DOCUMENTS FOR REVIEW AND FILES LOCATION

Please charge time to 5600015- 102. Design Consultant response period: 12-22-2014 to 1-12-2015.

TOWN OF COLCHESTER COUNTY OF CHITTENDEN PROPOSED IMPROVEMENT SIDEWALK AND RESURFACING PROJECT STP 5600(15)

**CONCEPTUAL PLANS
NOVEMBER 24, 2014**

PROJECT NAME:	COLCHESTER
PROJECT NUMBER:	STP 5600(I5)
FILE NAME:	General Plans.dgn
PROJECT LEADER:	J. LEINWOHL
DESIGNED BY:	T. DUGUAY
PLOT DATE:	11/24/2014
DRAWN BY:	T. DUGUAY
CHECKED BY:	J. LEINWOHL
<b>DALTON DRIVE SIDEWALK PLAN DD-01 SHEET 27 OF 35</b>

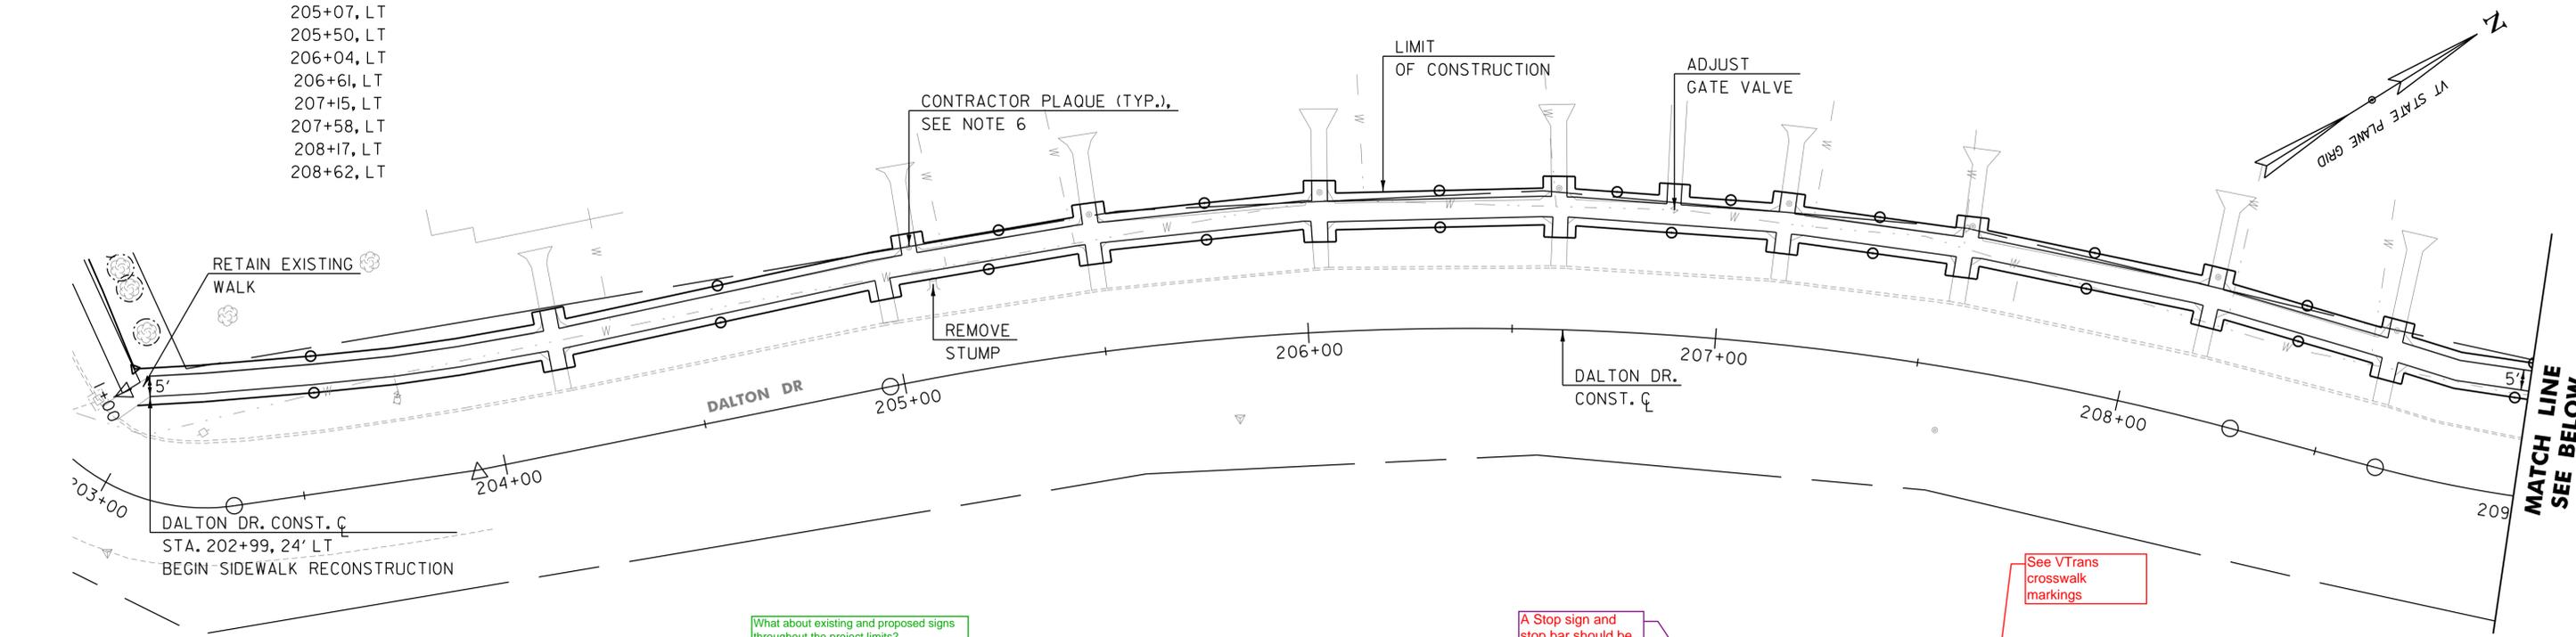
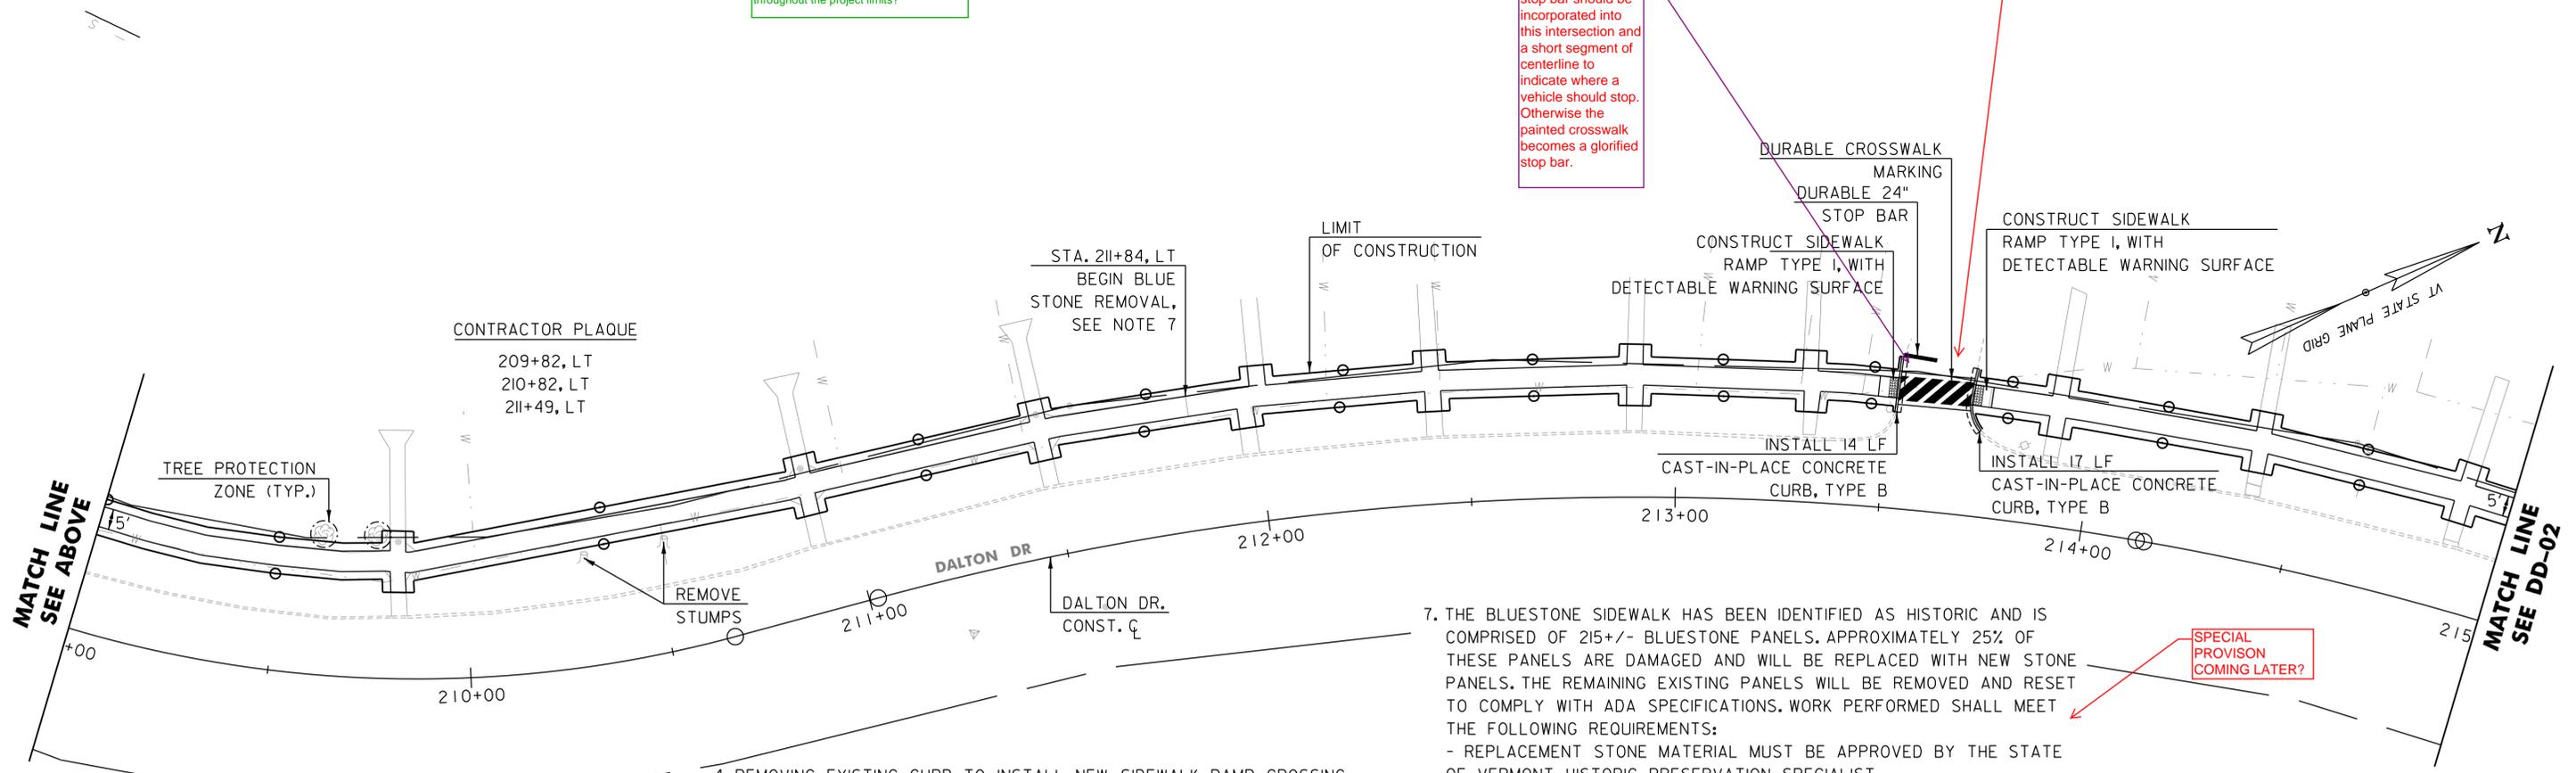
What about existing and proposed signs throughout the project limits?

A Stop sign and stop bar should be incorporated into this intersection and a short segment of centerline to indicate where a vehicle should stop. Otherwise the painted crosswalk becomes a glorified stop bar.

See VTrans crosswalk markings

PROJECT NAME:	COLCHESTER
PROJECT NUMBER:	STP 5600(I5)
FILE NAME:	General Plans.dgn
PROJECT LEADER:	J. LEINWOHL
DESIGNED BY:	T. DUGUAY
PLOT DATE:	11/24/2014
DRAWN BY:	T. DUGUAY
CHECKED BY:	J. LEINWOHL
<b>DALTON DRIVE SIDEWALK PLAN DD-02</b>	
SHEET 28 OF 35

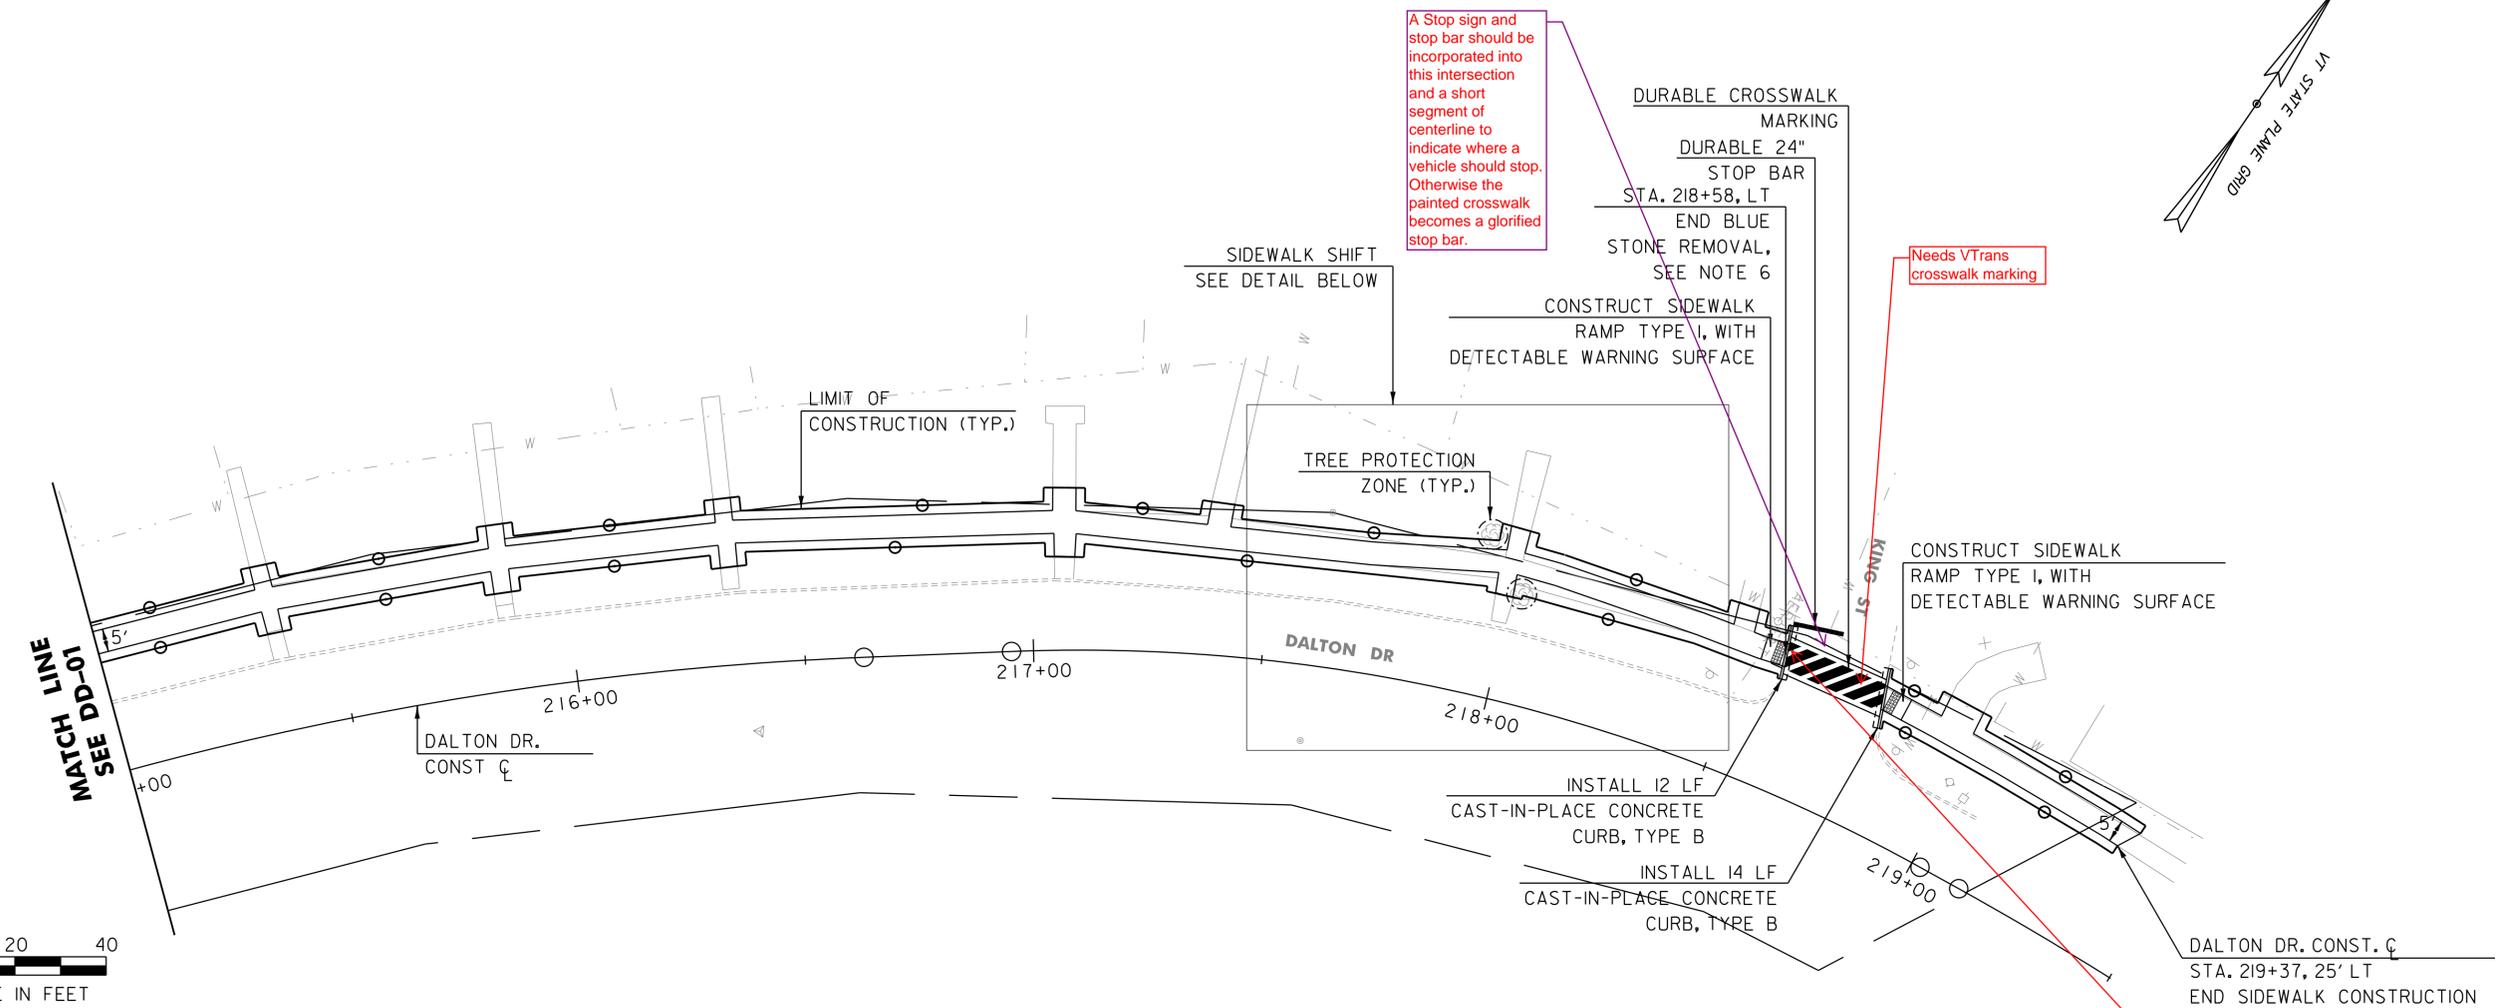
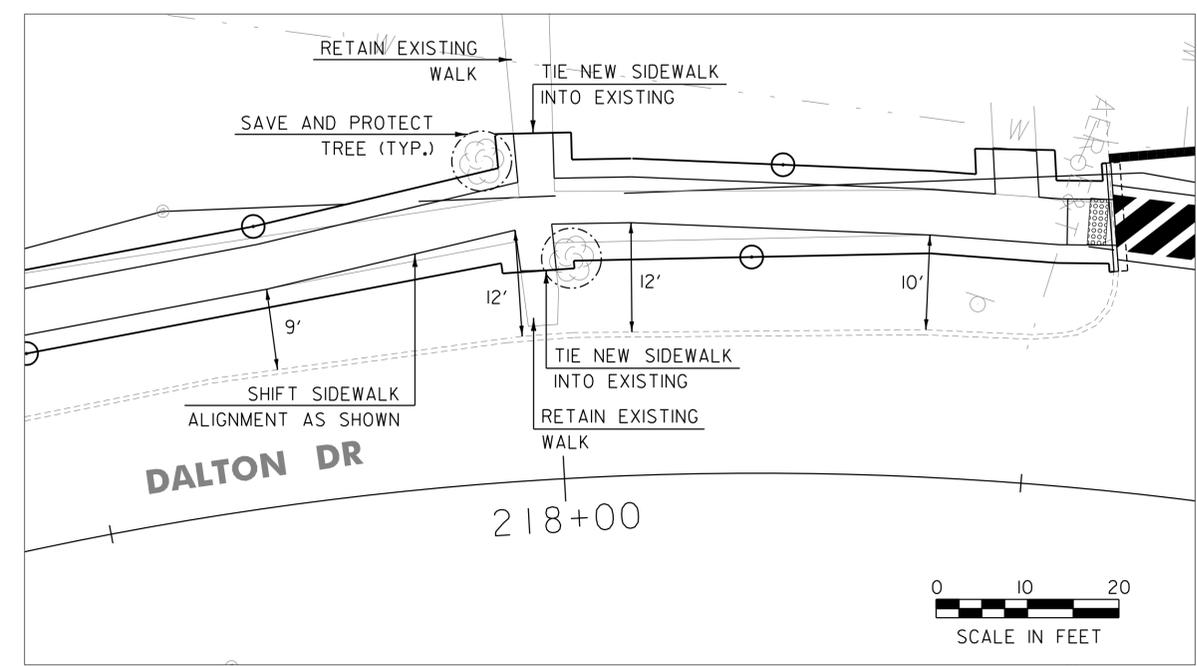
A Stop sign and stop bar should be incorporated into this intersection and a short segment of centerline to indicate where a vehicle should stop. Otherwise the painted crosswalk becomes a glorified stop bar.

Needs VTrans crosswalk marking

Replace bluestone with concrete at end to put in warning strip
